wężyk do pompowania kół 65cm (średnica gwintu 6mm) kpl. Makita TE00000345

Technical Information

Y08765

Title	Change of Motor assembly with Air pipe assembly
Model	MP100D
Country	All countries
Description	[1][2] Air pipe assemblies for production have been unified to ø6mm thread type. [3][4] Motor assembly for production have been changed according to [1][2]. Note: There is no difference in performance between ø6mm thread type and ø8mm thread type. However, the repairs are different. See below.

ø8mm thread ø6mm thread

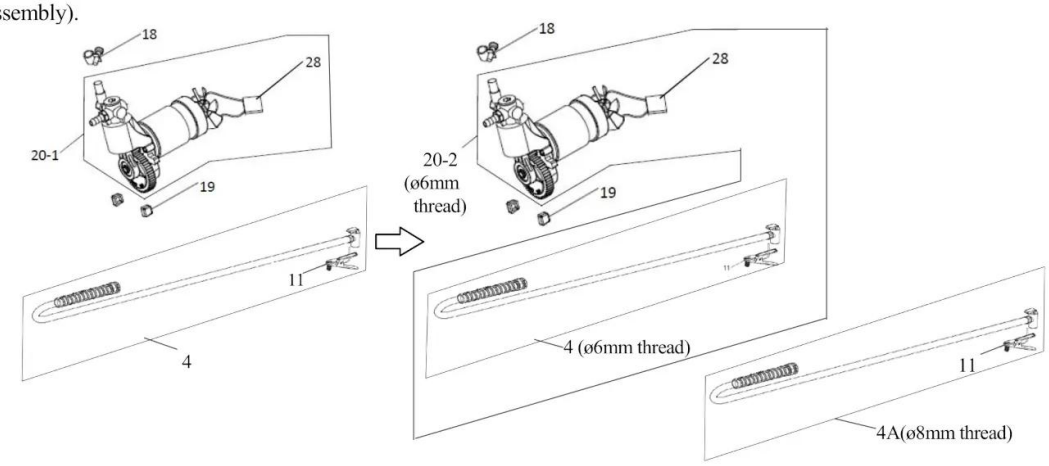
Current Air pipe assembly has either ø8mm or ø6mm threaded air pipe end as shown above.

New Air pipe assembly has the only ø6m threaded air pipe end.

Current Motor assembly has either ø8mm or ø6mm thread joint portion.

New Motor assembly has the only ø6mm thread joint portion.

Only Air pipe assembly wants to be replaced;
Check the thread diameter of the machine that the customer repairs, and order the same Air pipe assembly.

Motor assembly wants to be replaced;
Because of parts unification to ø6mm thread type, order the new Motor assembly (with ø6mm thread Air pipe assembly).
